Evaluation of LCRA's Proposal to Pump Groundwater from the Simsboro Aquifer

George Rice
December 15, 2014

Figure 2
GAM Predicted Discharges to Colorado River
(note: this simulation used the new LPGCD baseline pumping file (RUN50.wel), no additional pumping)

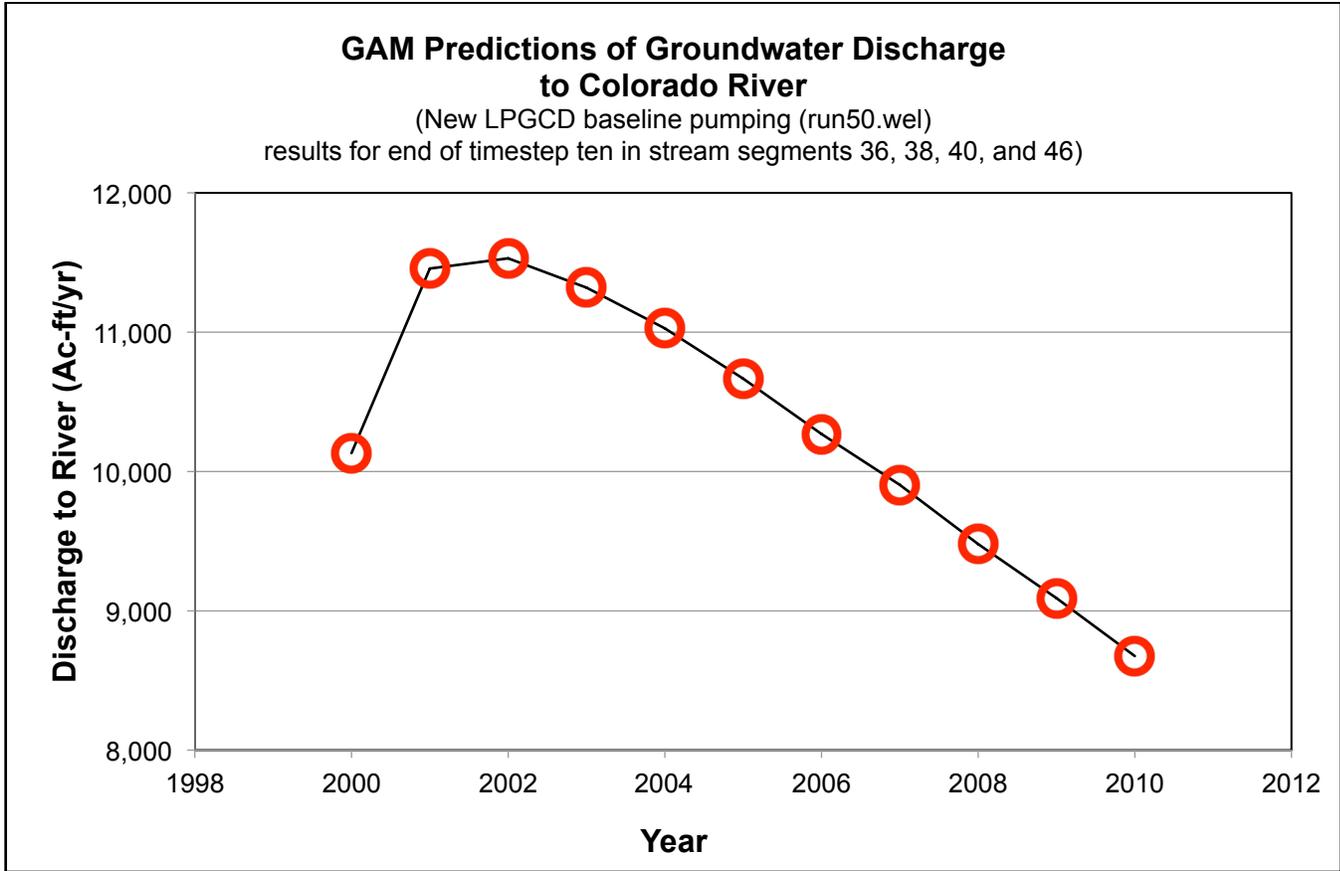
The answer to the first question appears to be no. Groundwater discharges to the Colorado River have been measured for the Carrizo-Wilcox Aquifer¹¹ in Bastrop County¹². The measurements ranged from about 22,000 to 36,000 acre-feet per year (table 4).

However, between the years 2000 to 2010, the GAM predicts groundwater discharges between 8,000 and 12,000 acre-feet per year (figure 2). Clearly, these predictions are inaccurate.

Figure 5
Effects of LCRA's Proposed Pumping on Colorado River

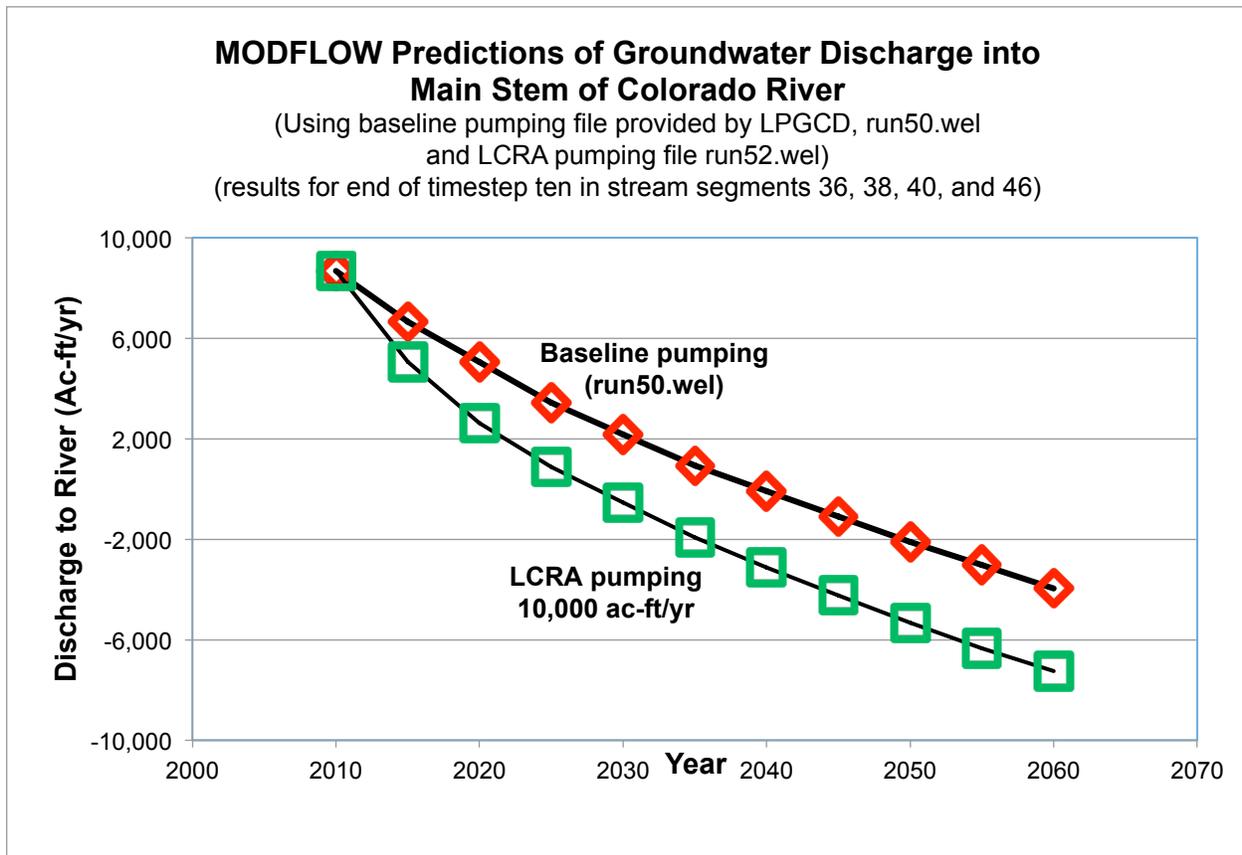
Figure 5 shows that LCRA's pumping would decrease groundwater discharge to the Colorado River.

The effects of LCRA's proposed pumping can be compared to the effects of LCRA's pumping combined with pumping by End Op and Forestar (figure A-1)¹⁵. As expected, the decline in the discharge of groundwater to the Colorado is accelerated for the combined pumping. As stated above, while the trend in the decline is reasonable, the amount of decline predicted by the GAM is not reliable.
